ADDENDUM NO. 4

Re: **GS# 102-272**
Residence Hall Renovations (Lawler-Harkins)
Delta State University
Cleveland, Mississippi

EXHIBIT "C"

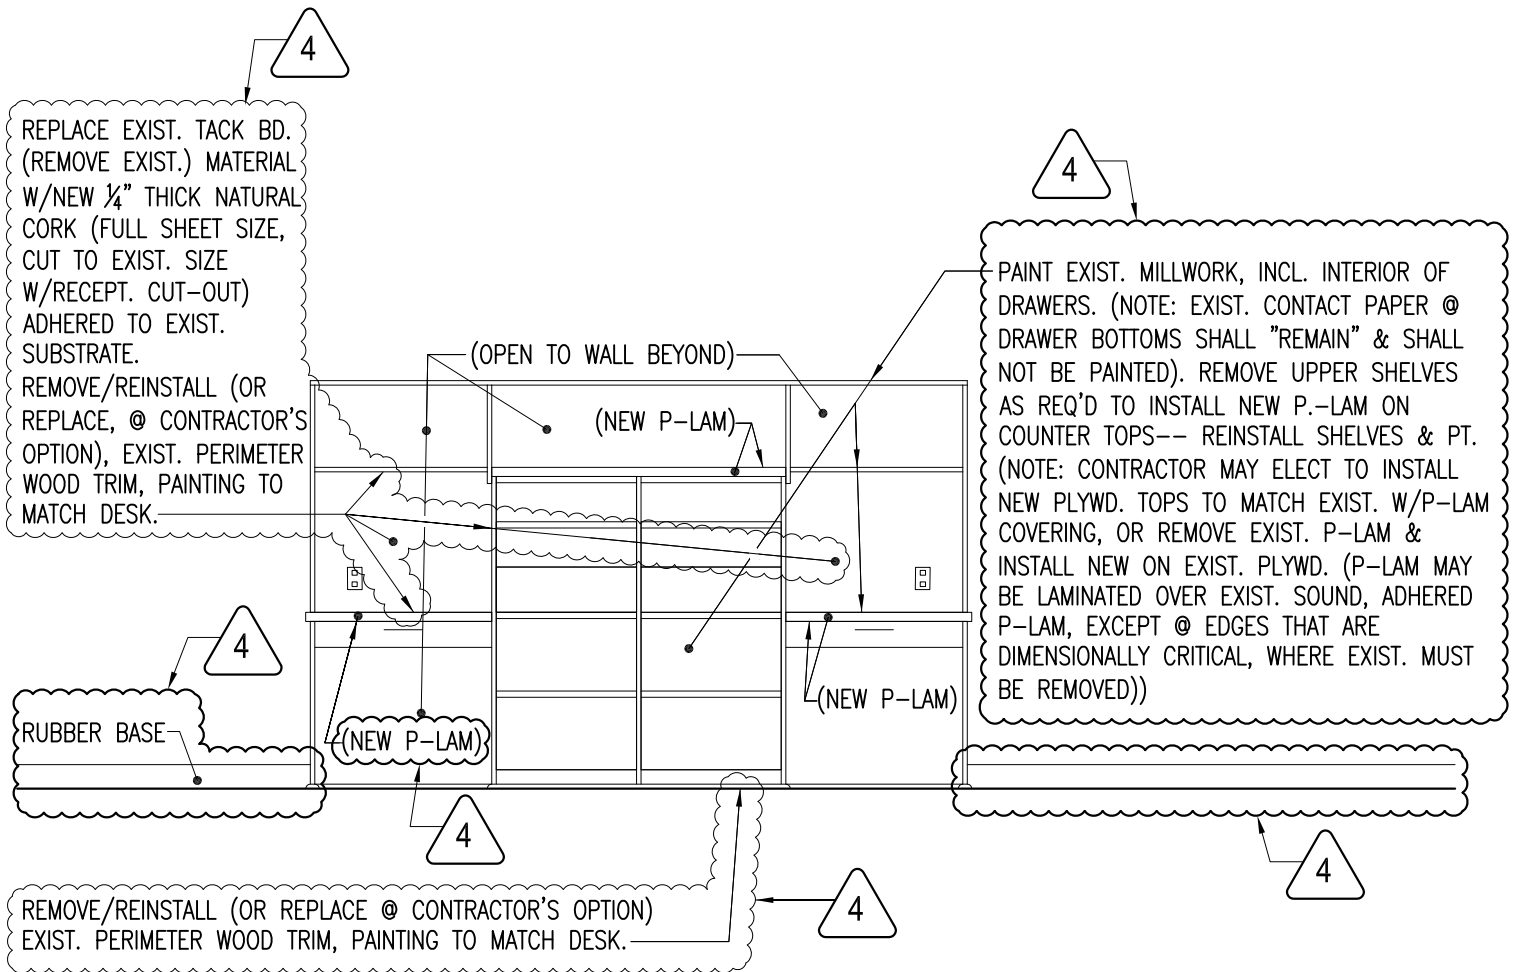
Item No. 6: Refer to Sheet 1.0, detail "5", and modify as per attached Exhibit "C".
